RE: OTHER CHANGE APPLICATION & EXTENSION TO CURRENCY PERIOD UPON LAND AT 880 CREEK ROAD, CARINA (COUNCIL REFERENCE A006989681)

We write in relation to the abovementioned application and Council's Information Request dated 12 May 2026.

Figure 1: Proposed Sales Office and pedestrian connection with car parking area

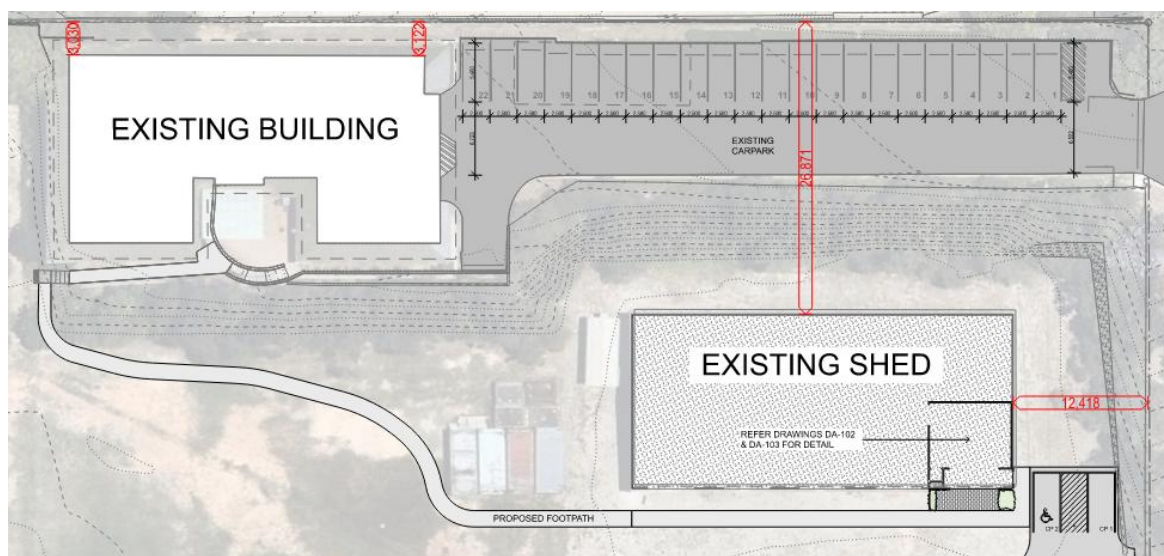
The submitted plans indicate that the existing car parking spaces and the proposed sales office are separated by existing landscaping and topography (a sloped area). It is therefore unclear whether the public will be required to exit the site and use the public verge along Bendena Terrace to access the sales office.

- a) Provide additional information and amended plans demonstrating a feasible pedestrian access route to the sales office that does not require customers to use the public verge as part of the operation.

The existing car parking area has access down to the level of the Sales Office with an existing staircase adjoining one of the existing buildings on site. The architectural plans prepared by *Deicke Richards* have been updated to illustrate the existing staircase as shown in Figure 1 .

A footpath is now proposed to be provided from the base of these stairs to the Sales Office until Stage 4 where the footpath will require removal to facilitate the Stage 4 construction. By Stage 4, it is anticipated that a display suite will be available in one of the constructed buildings, removing the need for the Sales Office. Notwithstanding, for the purposes of this development approval, the Sales Office is proposed to remain until physical removal is required to facilitate the construction of Stage 5 in the instance a separate Sales Office building is still required during construction and operation of Stage 4.
